Permit No: PRRES20241195
Plan Name:
Project Address: 4359 NE HIDEAWAY DR, LEES SUMMIT, MO 64064
Parcel Number: 284206

Our firm has been asked to make structural clarifications to the plans of the house to be built at the address listed above. During the permit review process the AHJ has questioned items. Below is a list of our recommendations along with the corresponding city item.

STRUCTURAL REVIEW
HD ENGINEERING & DESIGN
HD: 44934 DATE: 11/21/2022

5

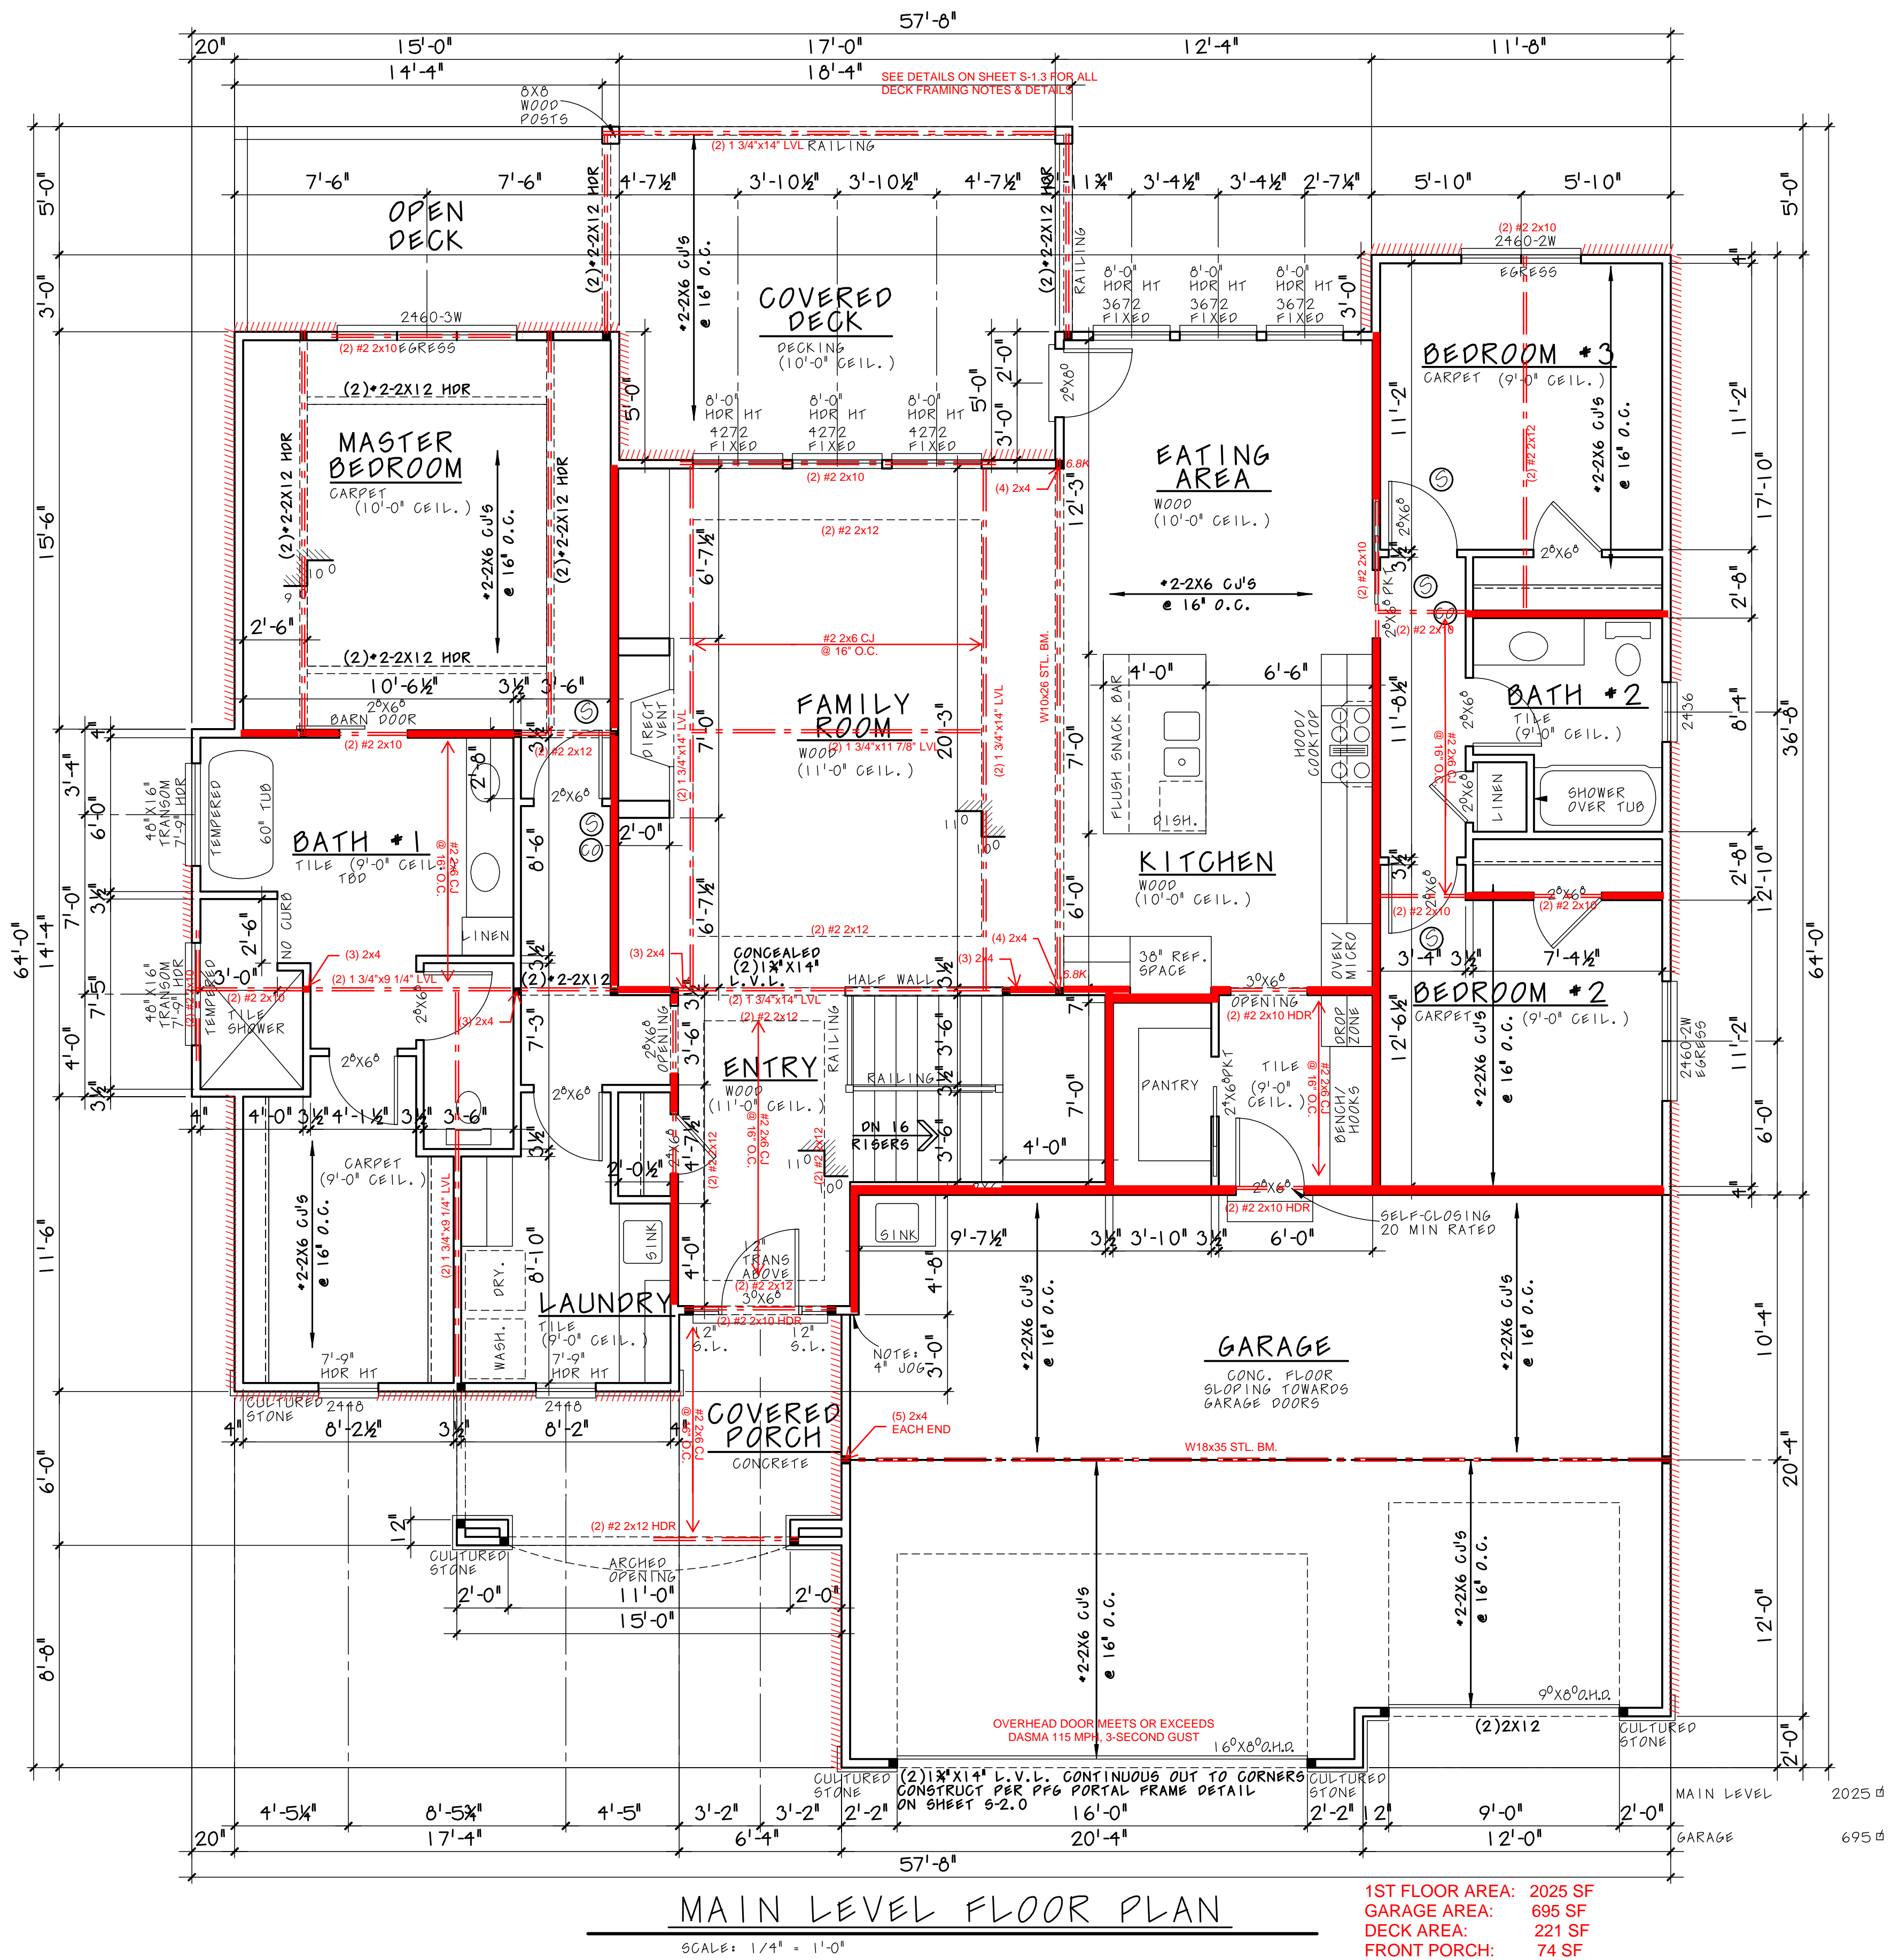
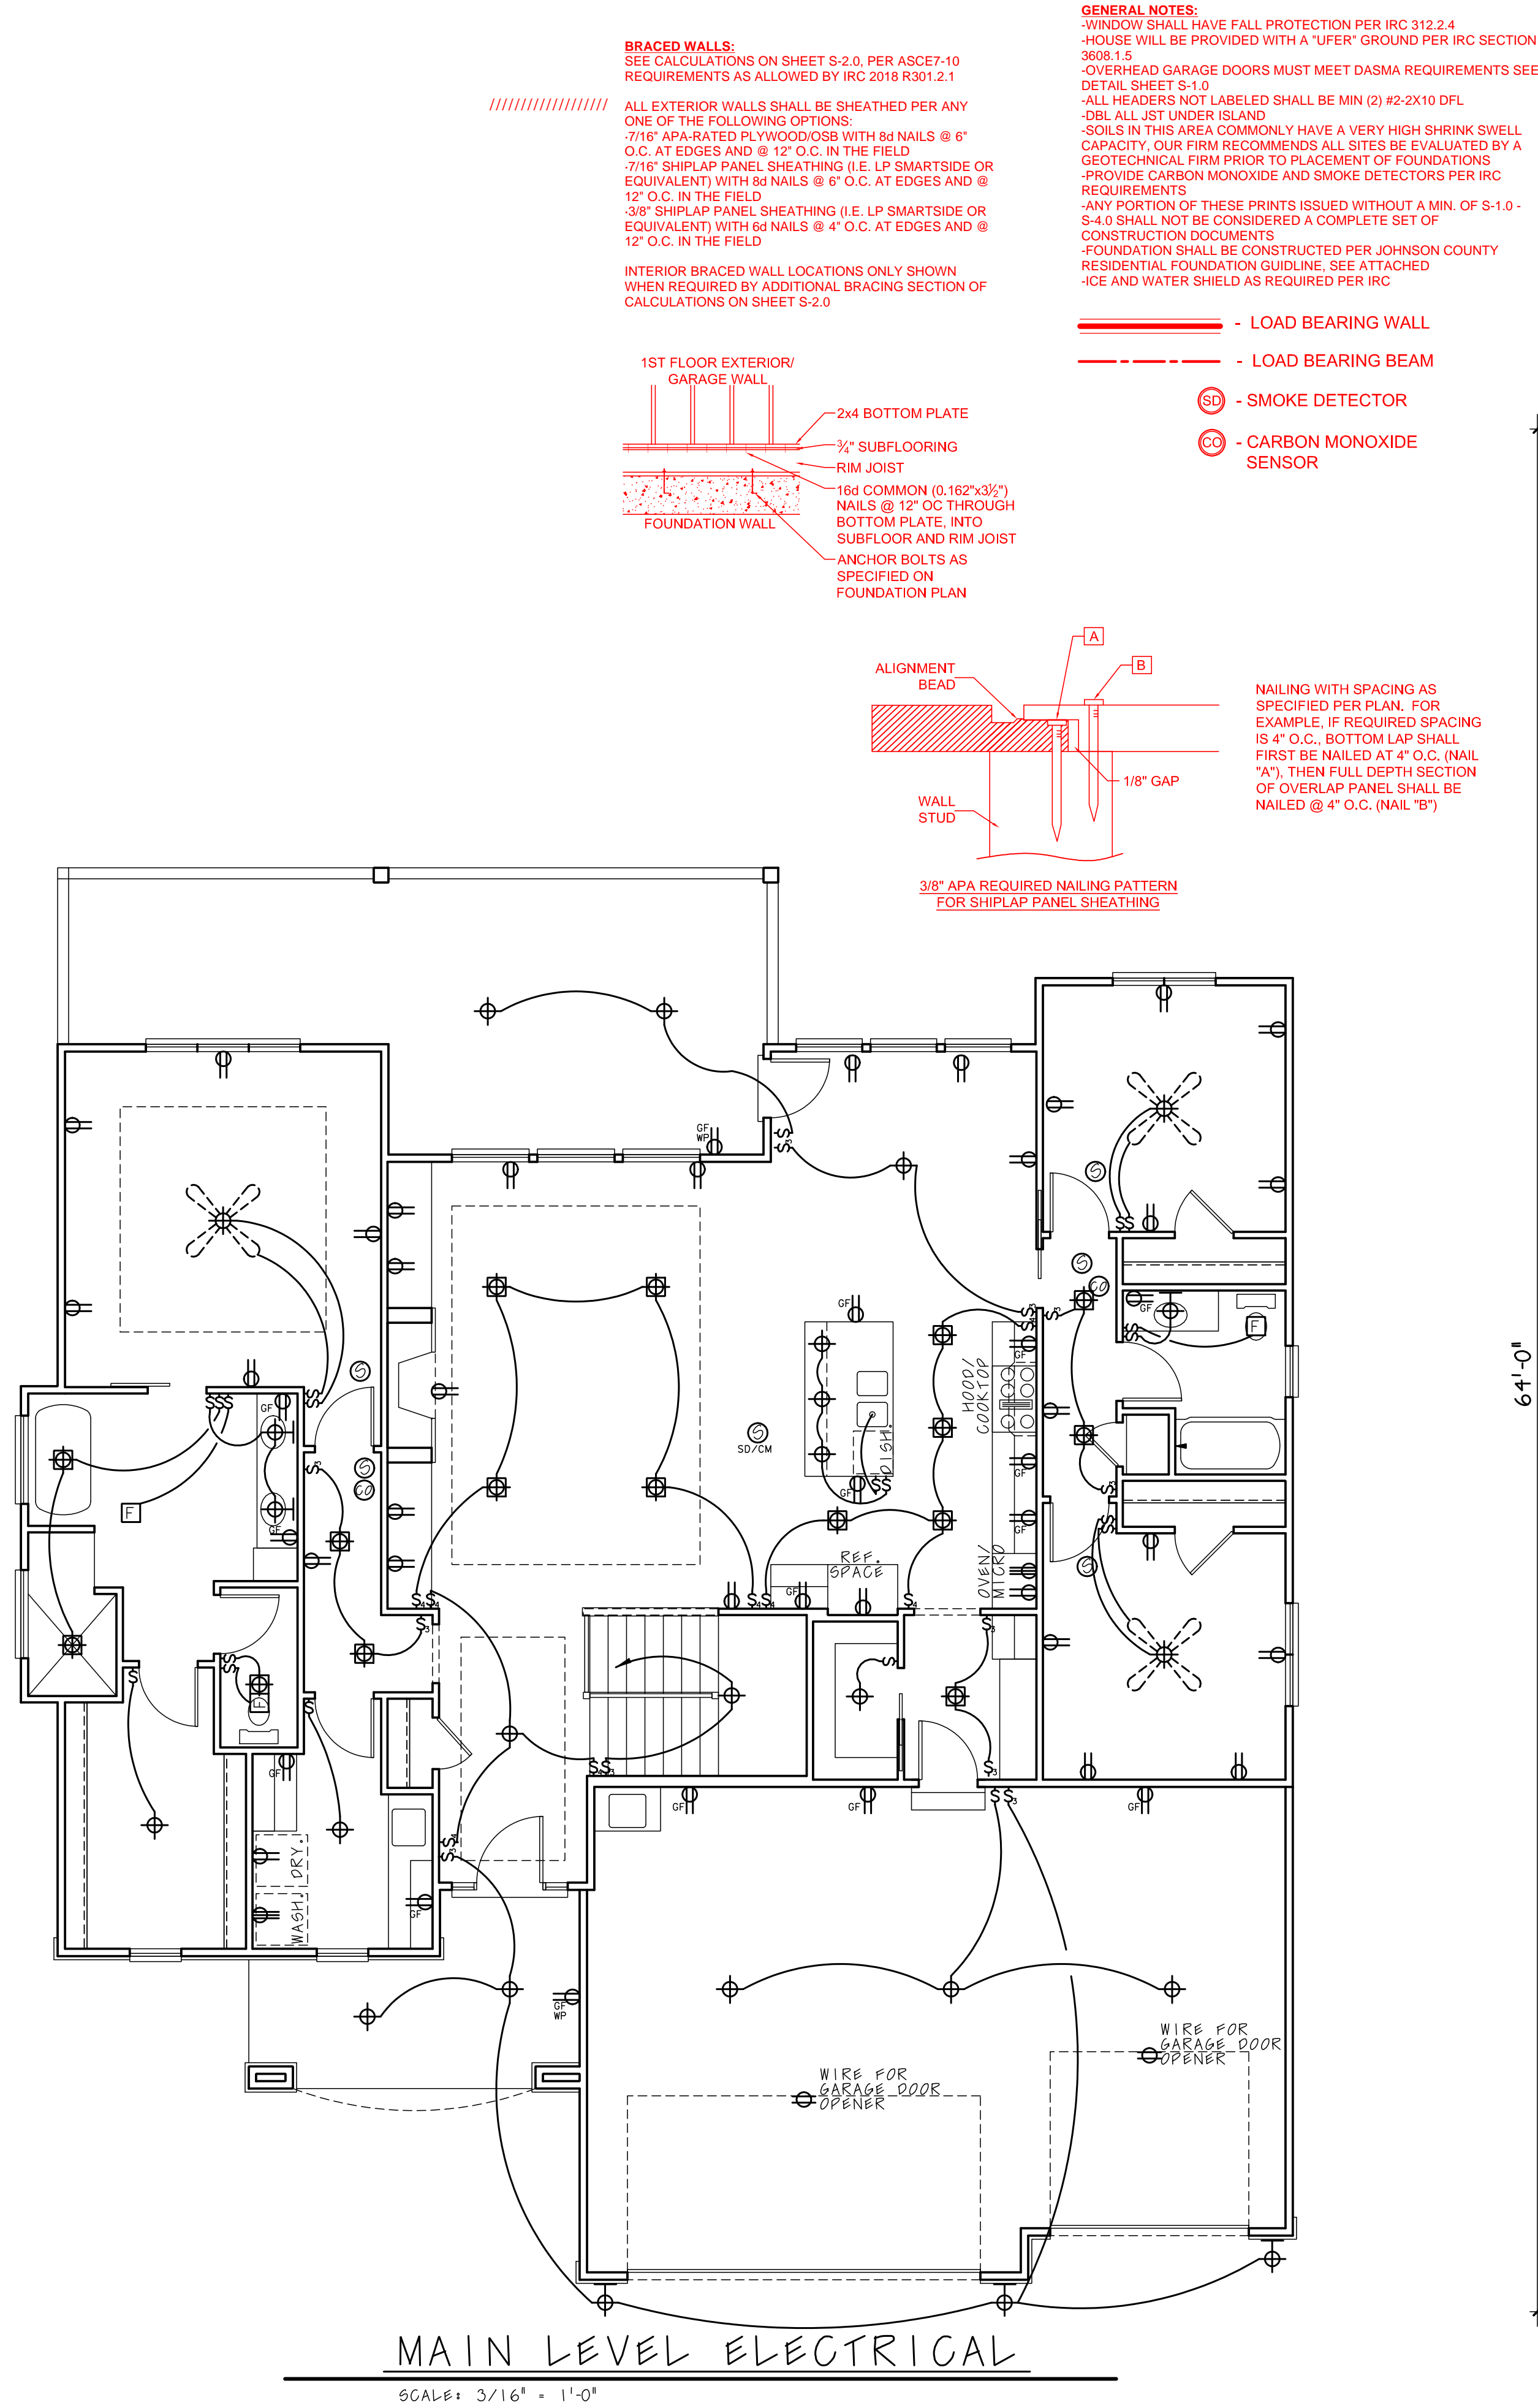
1. Provide combustion air calculations and specify transfer air grilles for fuel burning appliances located in confined space(s). (IRC Chapter 17 and Section G2407) **SEE CALCULATION ON S-1.3**
2. Footings, column pads, piers and grade beams - dimensions. (IRC Section R403) DECK PIER DETAIL NOT FOUND, SHOWS 12" DEEP PIER **SEE DETAIL AND NOTE ON SHEET 5**
3. Footings, column pads, piers and grade beams - reinforcement size and spacing. DECK PIER DETAIL NOT FOUND, SHOWS 12" DEEP PIER **SEE DETAIL AND NOTE ON SHEET 5**
